Access Compliance Report

Public Rights-of-Way

Intersection ID: 12266	Main Street: MORRIS_FIELD_DR	Cross Street: WILKINSON_BV	Location: SE
ADA ID: EA5945D1213A	Ramp Type: Perp	Initial Pass/Fail: Fail	Overall Compliance: No
Severity Score: 8.75			
Codes/Mitigation Info/Possible Solution		Field Measurements/Component Compliance

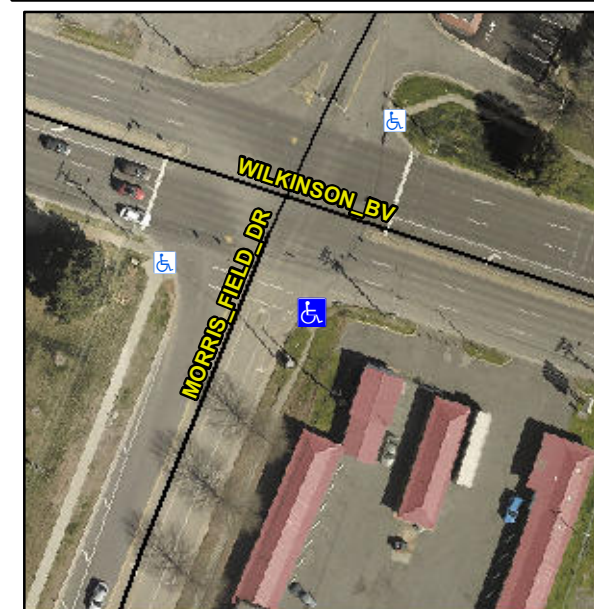
Not Found, R304.5.1

Compliance	Description	Data	Compliance	Description	Data
N/A	Ramp Length (in)	60.0	Yes	Ramp Slope (%)	7.0
No	Ramp Width (in)	47.0	Yes	Ramp XSlope (%)	1.4
N/A	Flare Type LT	N/A	N/A	Flare Type RT	N/A
N/A	Flare Slope LT (%)	N/A	N/A	Flare Slope RT (%)	N/A
N/A	Flare Traversable LT?	N/A	N/A	Flare Traversable RT?	N/A
N/A	Landing Length (in)	N/A	N/A	DWS Provided?	N/A
N/A	Landing Width (in)	N/A	N/A	DWS Contrast?	N/A
N/A	Landing Slope (%)	N/A	N/A	DWS Length (in)	N/A
N/A	Landing X Slope (%)	N/A	N/A	DWS Full Width?	N/A
N/A	Landing Curb? (Y/N)	N/A	N/A	DWS Offset (in)	N/A
N/A	Shared Landing?	N/A			
N/A	Gutter Ponding?	N/A	N/A	Gutter Slope (%)	N/A
N/A	Gutter Lip Ht (in)	N/A	N/A	Gutter X Slope (%)	N/A
N/A	Painted X Walk1?	Yes	N/A	Painted X Walk2?	N/A
	X Walk 1 Direction	To NW		X Walk 2 Direction	N/A
N/A	X Walk 1 Width (in)	110.0	N/A	X Walk 2 Width (in)	N/A
	X Walk 1 Slope (%)	0.2		X Walk 2 Slope (%)	N/A
	X Walk 1 X Slope (%)	1.6		X Walk 2 X Slope (%)	N/A

Remove & Replace Entire Ramp.
